November 8, 2005
LIC-05-0119

**SUBJECT: Fort Calhoun Station Unit No. 1 License Amendment Request (LAR) 05-013,
"Criticality Control During Spent Fuel Cask Loading in the Spent Fuel Pool"**

Omaha Public Power District's Evaluation
for
Amendment of Operating License

“Criticality Control During Spent Fuel Cask Loading in the Spent Fuel Pool”

Figure 2-11

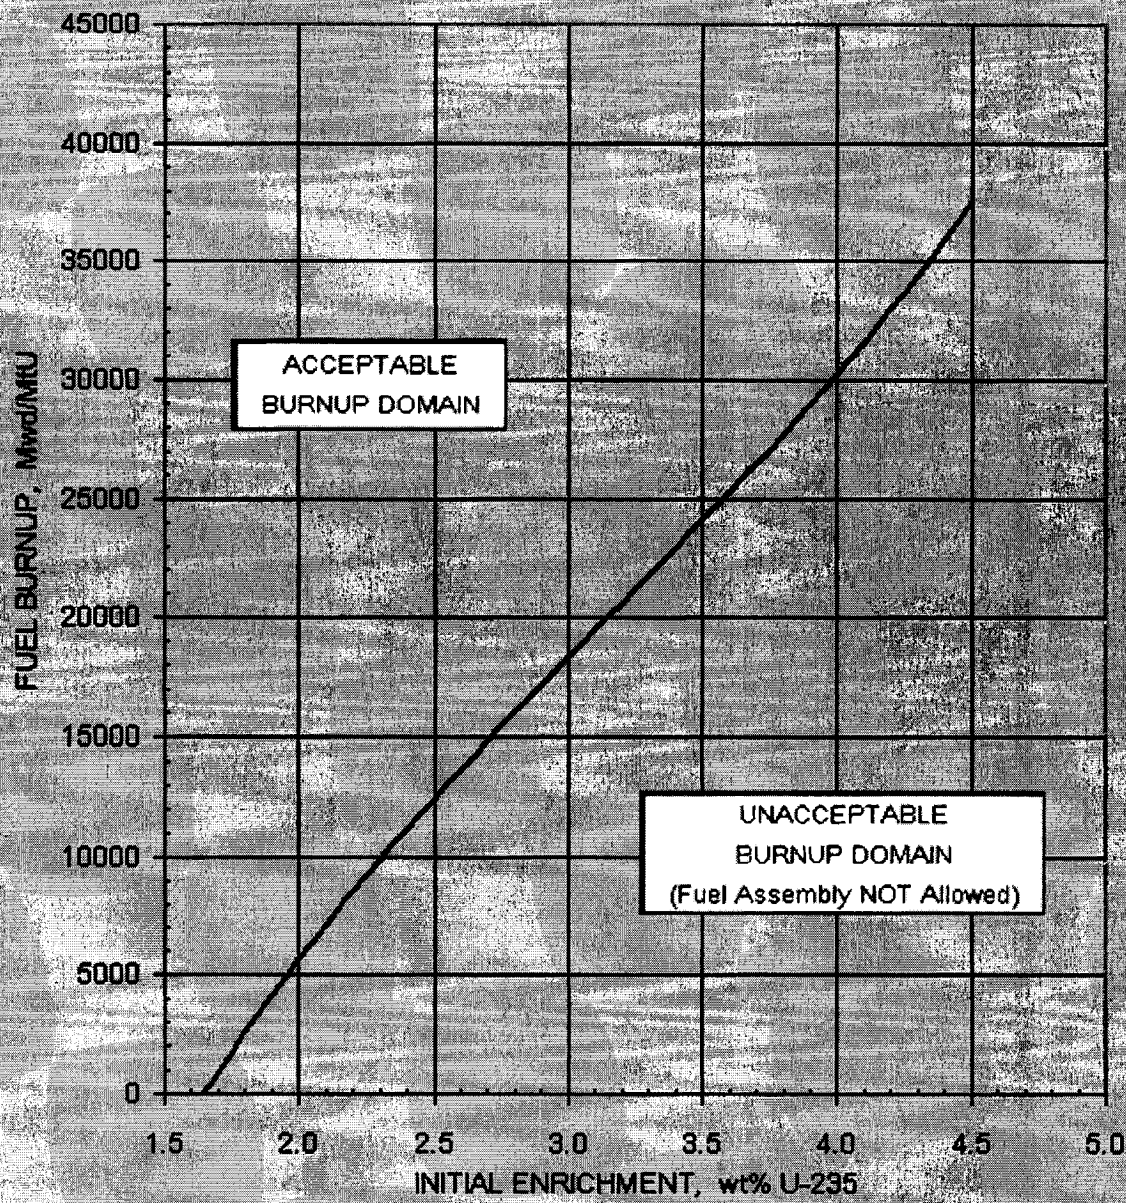
- (1) The spent fuel pool boron concentration shall be ≥ 800 ppm, and
- (2) The combination of initial enrichment and burnup of each spent fuel assembly located in a spent fuel storage cask in the spent fuel pool shall be within the acceptable burnup domain of Figure 2-11.

The spent fuel cask is designed for subcriticality by use of neutron absorbing material. The restrictions on the placement of fuel assemblies within the spent fuel pool, according to Figure 2-11, and the accompanying LCO, ensure that the k_{eff} of the spent fuel pool always remains ≤ 0.95 assuming the pool to be flooded with borated water and < 1.0 assuming the pool is flooded with unborated water, in accordance with 10 CFR 50.68(b)(4).

Figure 2-11

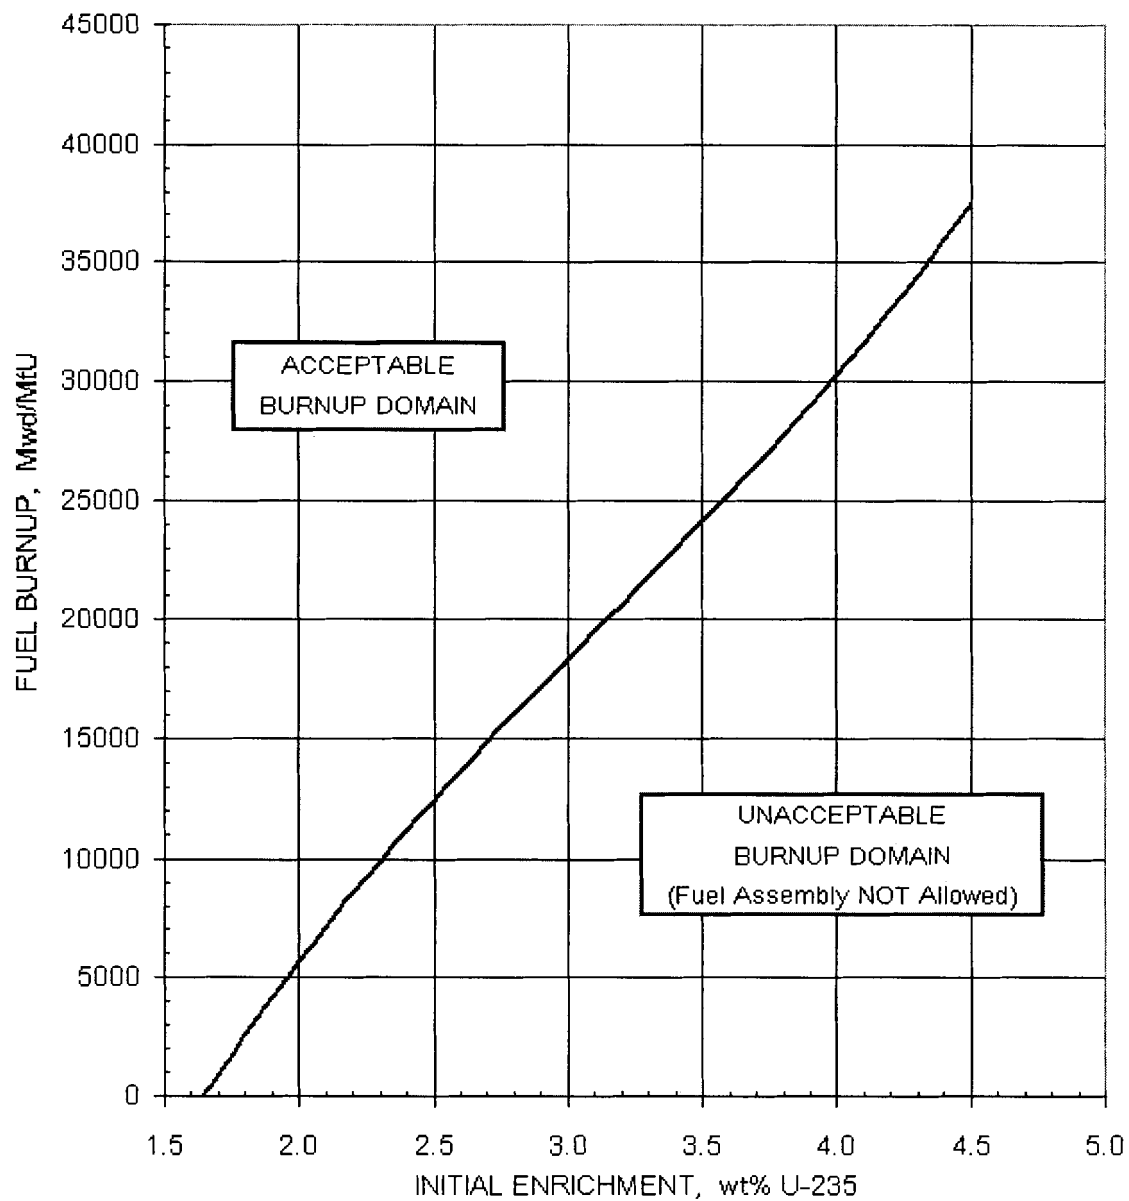
- (1) The spent fuel pool boron concentration shall be ≥ 800 ppm, and
- (2) The combination of initial enrichment and burnup of each spent fuel assembly located in a spent fuel storage cask in the spent fuel pool shall be within the acceptable burnup domain of Figure 2-11.

The spent fuel cask is designed for subcriticality by use of neutron absorbing material. The restrictions on the placement of fuel assemblies within the spent fuel pool, according to Figure 2-11, and the accompanying LCO, ensure that the k_{eff} of the spent fuel pool always remains < 0.95 assuming the pool to be flooded with borated water and < 1.0 assuming the pool is flooded with unborated water, in accordance with 10 CFR 50.68(b)(4).
